To: Diane M. O'Keefe Attn: Thomas Sancken
From: Ralph E. Anderson By: Todd E. Ahrens
Subject: BRIDGES AND STRUCTURES
Date: April 10, 2003

FAP Route 627
Section U-BR
LaSalle County

P-93-047-02
SN 050-0030 (Existing)

IL Route 71 over unnamed creek

BRIDGE DECK CROSS SECTIONS

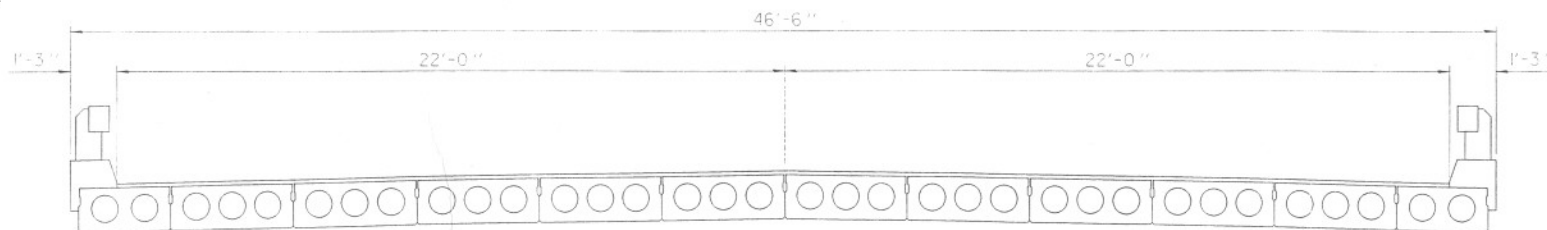
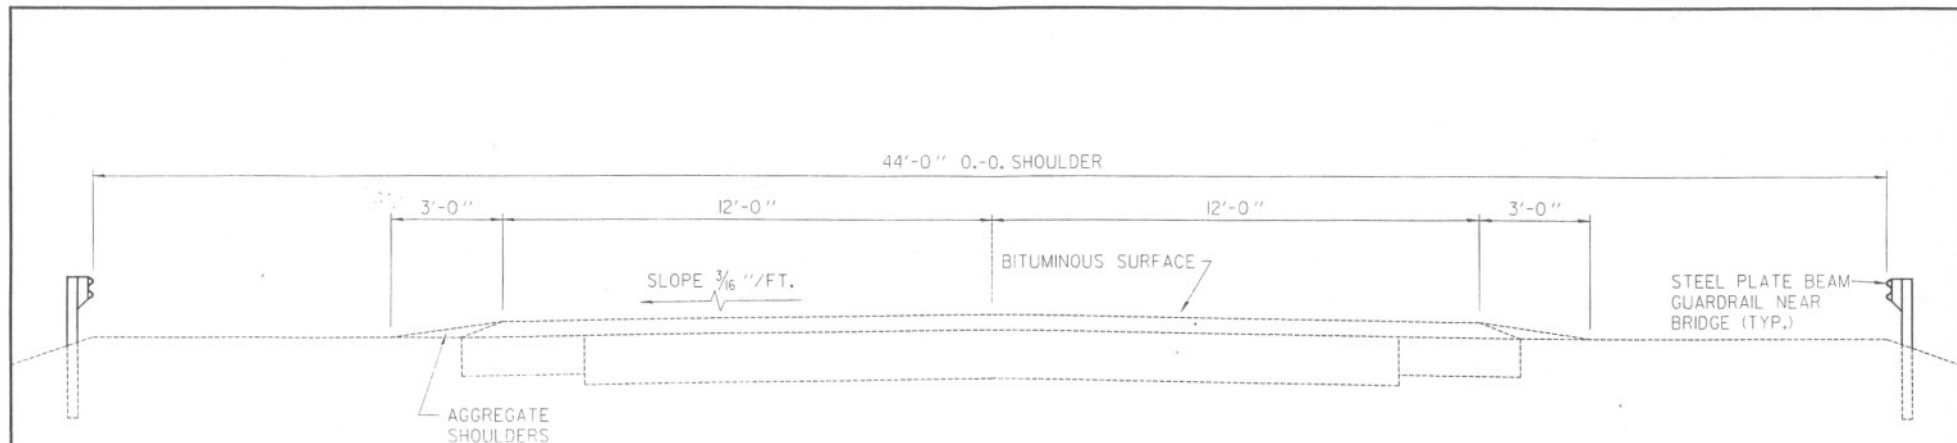
1. Based on the deteriorated condition of the existing structure we agree with the recommendation of complete replacement. Stage construction appears feasible. We agree with the recommended bridge clear width of 32'-0".
2. Replacement structure type, length, number and location of piers, low beam, profile grade, and location relative to existing structure subject to approval of the Hydraulic Report and review during the TSL plan phase of the project.
3. Foundation borings will be required for this project. Guidelines for locating structure borings can be found in Section 1.2 of the Departments Geotechnical Manual. Please contact our Foundation Unit if additional assistance is required.

Subject to the above comments, the Bridge Condition Report is approved. A Type, Size, and Location (TSL) plan will be required for this project. Please submit soil borings, structure report, proposed cross section and proposed plan and profile so that our office may begin work to complete these plans.
